To: Rob Balland, Paramounte Engineering
From: Brian Chambers, Assistant Director, 910.342.2782
CC: File;
Date: 12/1/2023
Re: The Avenue TRC Rev 4

RE: The Avenue TRC Rev 3 Comments

Project Name: **THE AVENUE**

Figure 2B-22. Example of Regulatory and Warning Signs for a One-Lane Roundabout

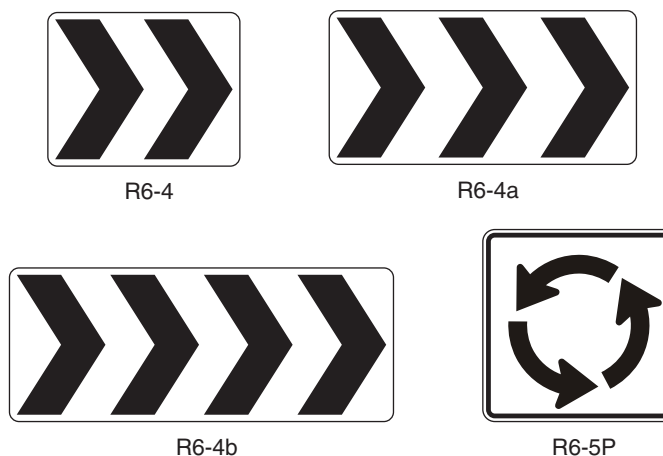
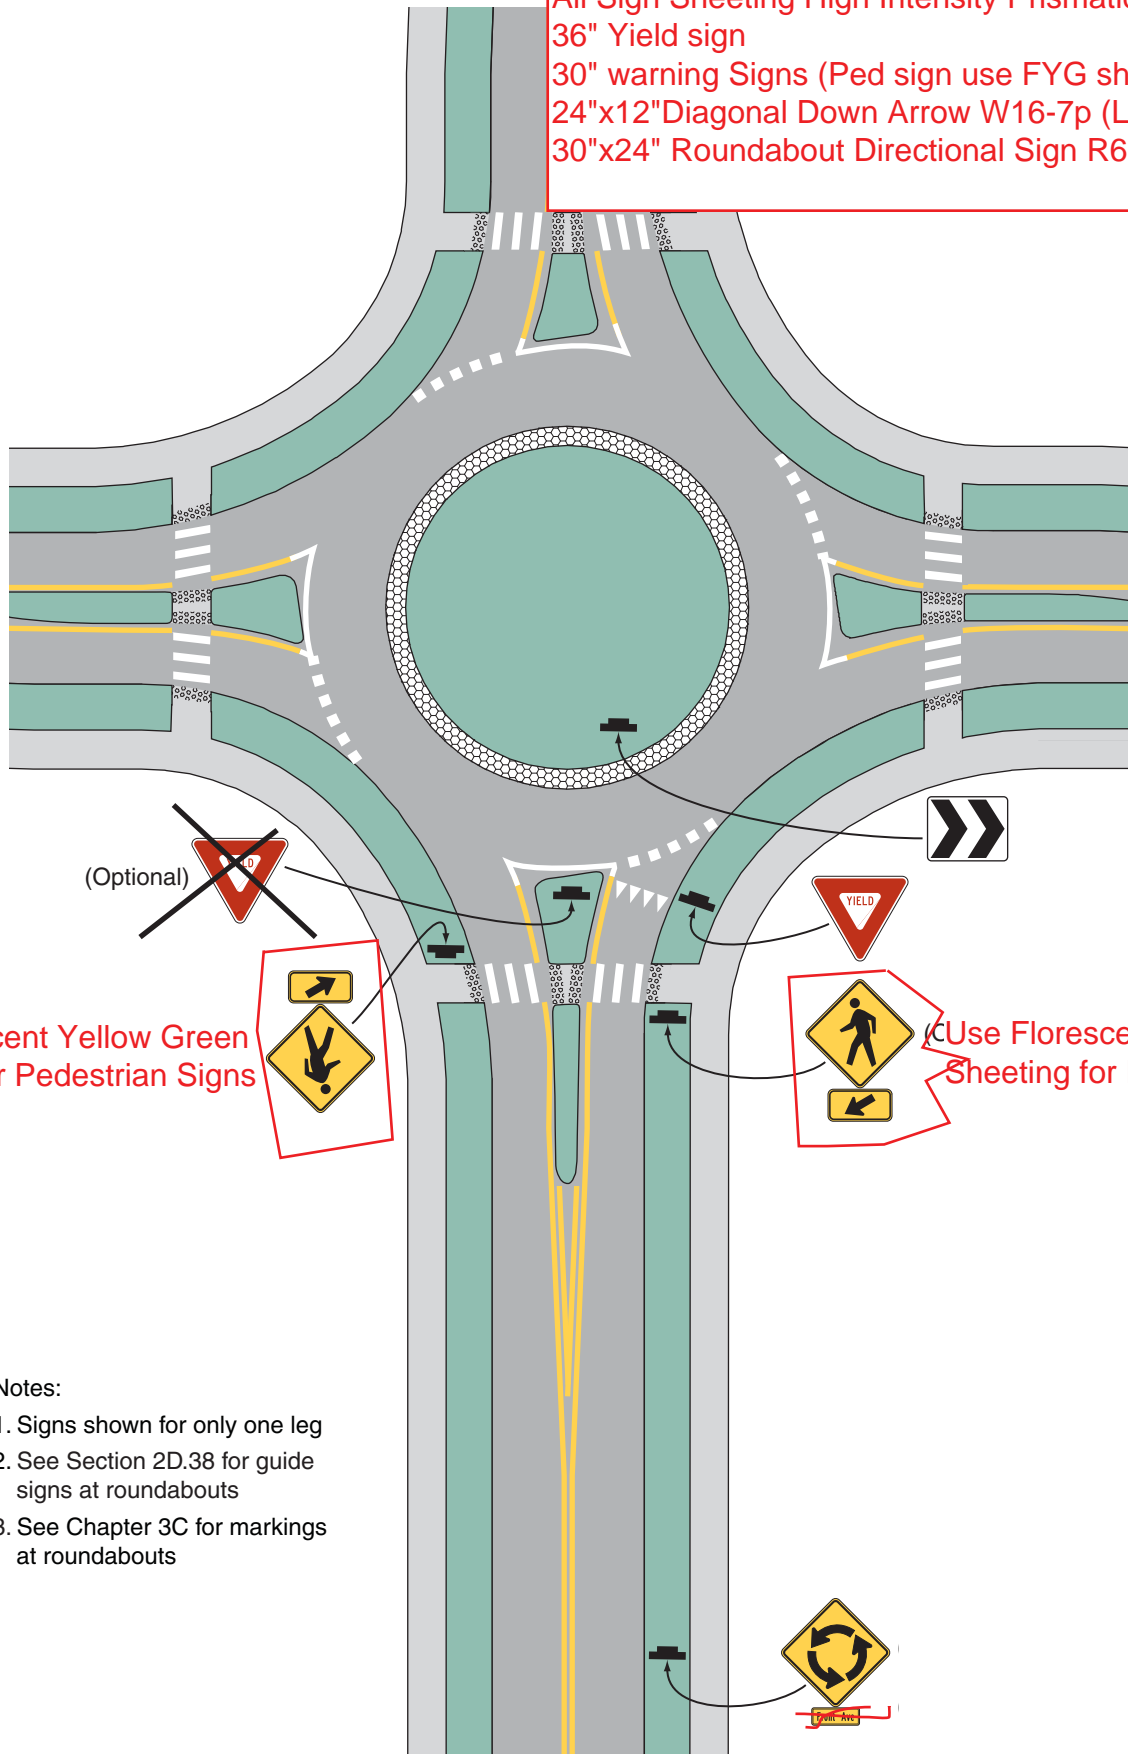
- 2. Review the roundabout signage, I have attached some guidance for reference. The current standard uses R6-4 signs in the center island not One-Way signs.*
- 3. I did not see sheet C-6.0A which is referenced to be sign and striping details.*
- 4. (see attachment)*

★ Replace One Way w/ chevron

All Sign Sheeting High Intensity Prismatic
 36" Yield sign
 30" warning Signs (Ped sign use FYG sheeting)
 24"x12" Diagonal Down Arrow W16-7p (L) (R) (FYG)
 30"x24" Roundabout Directional Sign R6-4)

Use Florescent Yellow Green Sheeting for Pedestrian Signs
